Access Compliance Report

Public Rights-of-Way

(Curb Ramps)

Intersection ID: 45794	Main Street: SHELLVIEW_LN	Cross Street: GRANITE_TRAIL_LN	Location: NE
ADA ID: 60BFC8542A0C	Ramp Type: BlendTrans1	Initial Pass/Fail: Fail	Overall Compliance: No
Severity Score: 12.5			
Codes/Mitigation Info/Possible Solution		Field Measurements/Component Compliance

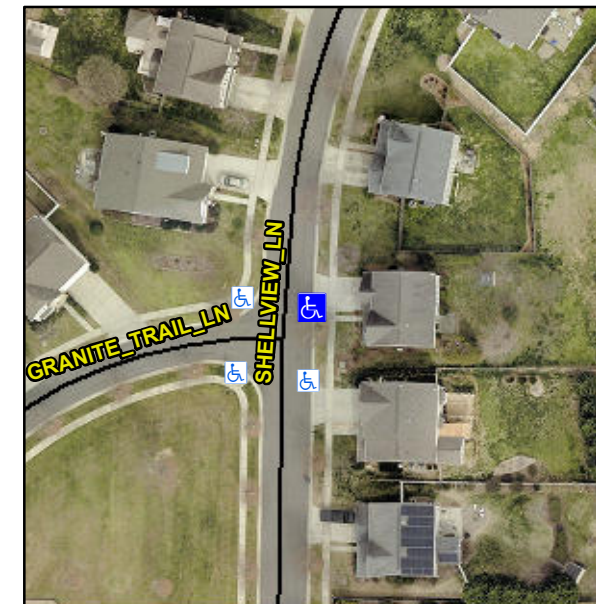
Not Found, R304.5.3

Compliance	Description	Data	Compliance	Description	Data
N/A	Ramp Length (in)	73.0	Yes	BlendTrans Slope (%)	2.1
Yes	Ramp Width (in)	48.0	No	BlendTrans XSlope (%)	5.1
N/A	Flare Type LT	N/A	N/A	Flare Type RT	N/A
N/A	Flare Slope LT (%)	N/A	N/A	Flare Slope RT (%)	N/A
N/A	Flare Traversable LT?	N/A	N/A	Flare Traversable RT?	N/A
N/A	Landing Length (in)	N/A	N/A	DWS Provided?	N/A
N/A	Landing Width (in)	N/A	N/A	DWS Contrast?	N/A
N/A	Landing Slope (%)	N/A	N/A	DWS Length (in)	N/A
N/A	Landing X Slope (%)	N/A	N/A	DWS Full Width?	N/A
N/A	Landing Curb? (Y/N)	N/A	N/A	DWS Offset (in)	N/A
N/A	Shared Landing?	N/A			
N/A	Gutter Ponding?	N/A	N/A	Gutter Slope (%)	N/A
N/A	Gutter Lip Ht (in)	N/A	N/A	Gutter X Slope (%)	N/A
N/A	Painted X Walk1?	No	N/A	Painted X Walk2?	N/A
	X Walk 1 Direction	To W		X Walk 2 Direction	N/A
	X Walk 1 Width (in)	N/A		X Walk 2 Width (in)	N/A
	X Walk 1 Slope (%)	3.1		X Walk 2 Slope (%)	N/A
	X Walk 1 X Slope (%)	3.0		X Walk 2 X Slope (%)	N/A

N/A	Ramp inside XWalk1?	N/A	N/A	Ramp inside XWalk2?	N/A
	Road Slope (%)	3.0		Clear Space?	N/A
	Road X Slope (%)	3.1	N/A	Clear Space to XWalk (in)	N/A
N/A	Any Obstructions?	N/A	N/A	Storm Grate/Utility Hazard?	N/A
	Obstruction Type			Storm Grate/Utility Type	
		N/A			N/A
			Yes	Surface Condition? (G/P)	Good
			No	Curb Slope (%)	21.4

Remove & Replace Curb Ramp With Two New Directional Ramps or Equivalent.
